Technical Service Information

THM 4L80-E 1-2 SLIDE BUMP

Figure 1

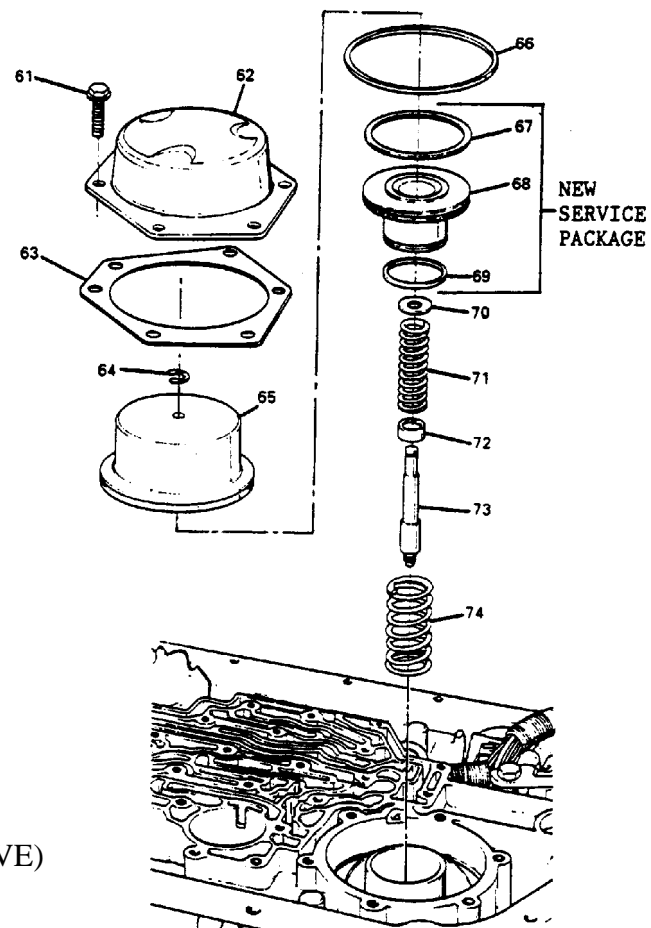
- COMPLAINT:** Some THM 4L80-E transmissions may exhibit a 1-2 slide and/or harsh double bump feel.
- CAUSE:** The cause may be, fluid leaking past the 1-2 accumulator piston seals. The 1-2 accumulator piston is located inside of the reverse servo piston (See Figure 1).
- CORRECTION:** Install a new design 1-2 accumulator piston and ring assembly to eliminate this condition. The new service package is available under OEM part number 8680929. Refer to Figure 1 for assembly.
